MEMORANDUM

To: Surfrider Foundation

From: David Revell, PhD

Subject: Huntington Beach Desalination Review of Sea Level Rise Hazards

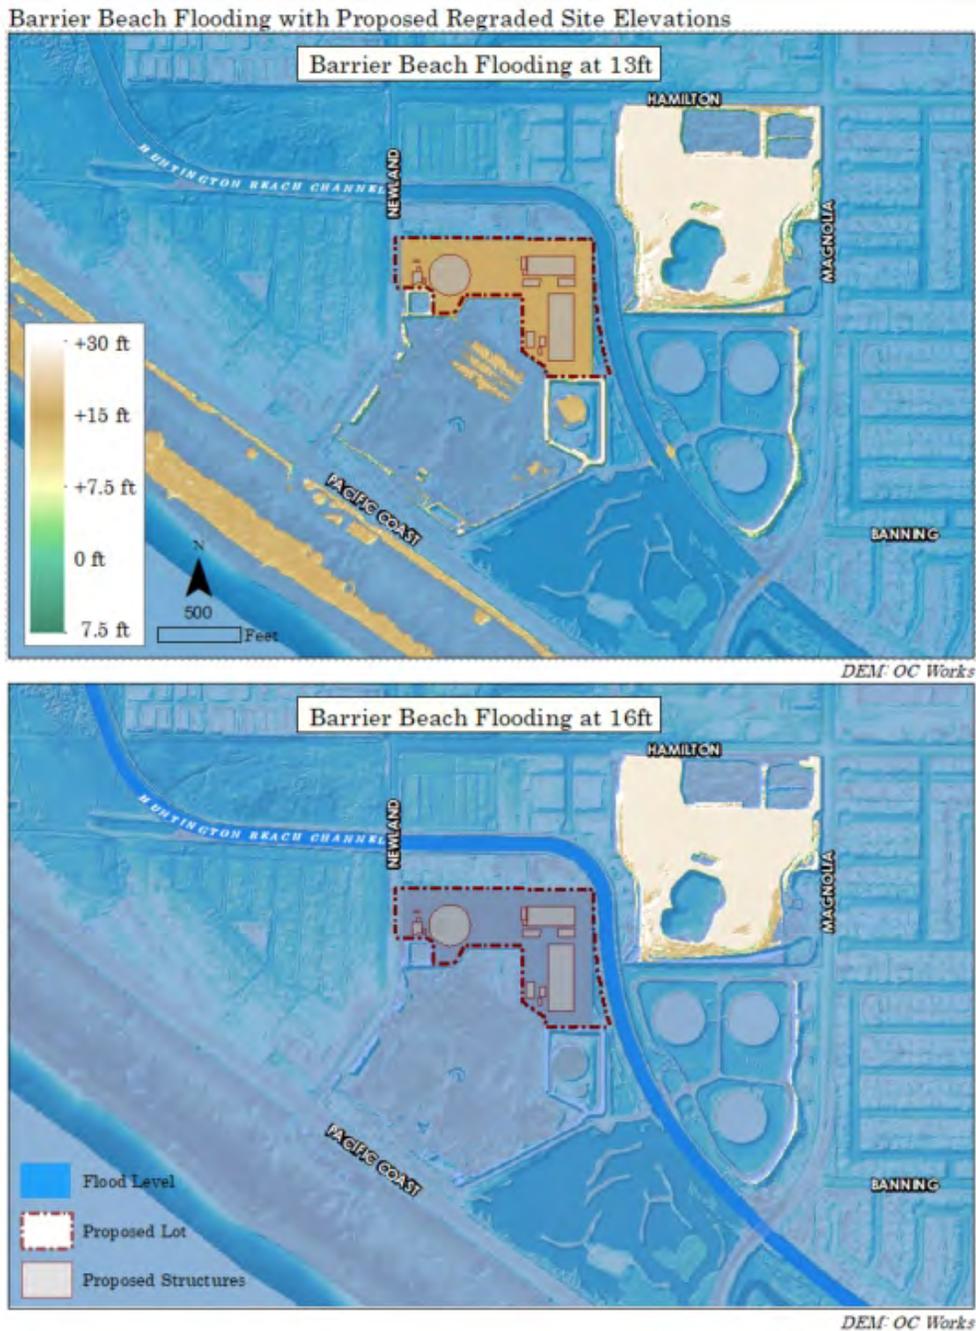
The Huntington Beach Channel and the Santa Ana River were all historically bar built estuaries which meant that the sand berm fronting the estuary would open and close seasonally in response to wave energy and river flows. When the beach berm closes, water fills the channel/estuary like a bath tub to the elevation set by the beach berm crest. By evaluating available topographic data for the nearby beach berm crest during late summer/fall conditions, it was determined that the berm crest elevation routinely reaches between 12 and 15 feet NAVD. Assuming a beach berm crest of 13 feet was reached and not artificially breached, then barrier beach flooding today could potentially reach the top of the existing flood control channel. With any amount of sea level rise, this closed barrier beach flooding could overtop the Huntington Beach Channel and potentially inundate the proposed site. Considering proposed regraded site elevations, any amount of sea level rise over 1 foot could inundate the proposed facility site (Figure 8).
